RESPONSE LETTER NO. 1 TO REQUEST FOR INFORMATION

Project Title: **Metrorail Public Address System Replacement**

Project No.: **TP-000008807**

DIAGRAM #2

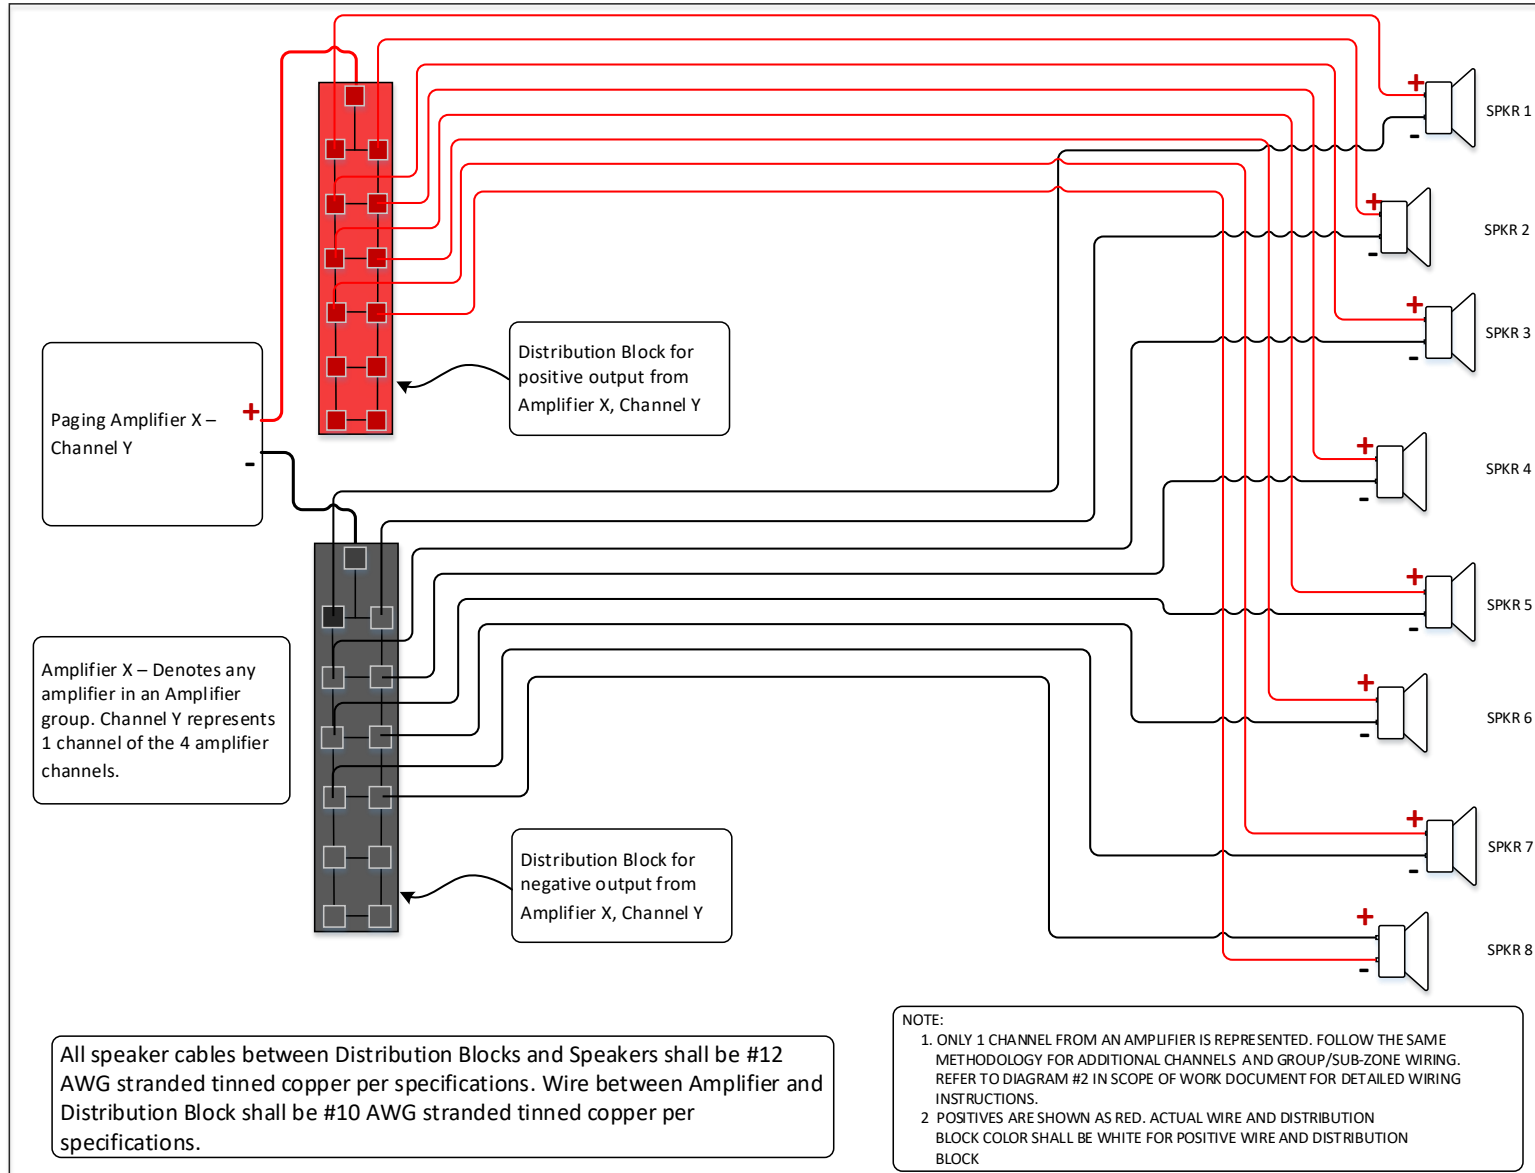
QUESTION No.1: As per BID Document: APPENDIX A, Summary of Work, Page 10 of 66 and Page 11 of 66 Topic WIRING BETWEEN DISTRIBUTION BLOCKS AND SPEAKERS IN A SUB-ZONE it reads “.....**Pass-through wiring and/or daisy chain wiring methods between speakers shall not be permitted. All speaker cables shall be direct run to approved distribution blocks.**” But the diagram shown on page 21 of 66 shows a daisy chain connection.

Please can you clarify if we can use the daisy chain method between speakers or if we must run one dedicated cable for each speaker from the terminal block to the speaker.

ANSWER No.1: The single line wiring schematic that is presented on page 21 is the electrical equivalent of the wiring procedure that is provided on page 23 of 66 in the attached three-page excerpt document and is not intended to be the actual wiring procedure to be used. Note that no connection blocks are show in the wiring representation on page 21, The wiring procedure on page 23 will ensure that the requirements of the highlighted bullet item on page 10 of 66, and items 46 and 47 in APPENDIX A - SUMMARY OF WORK for RPQ No.: TP-0000008807 are met. All referenced pages are included in the document named Solartes-8-18-23_1220pm-Q1.pdf included with this response. Dedicated runs are required. Please note that the attachments under this RFI are the same as the one on the solicitation documents and are provided for informational (illustrational) purposes only.
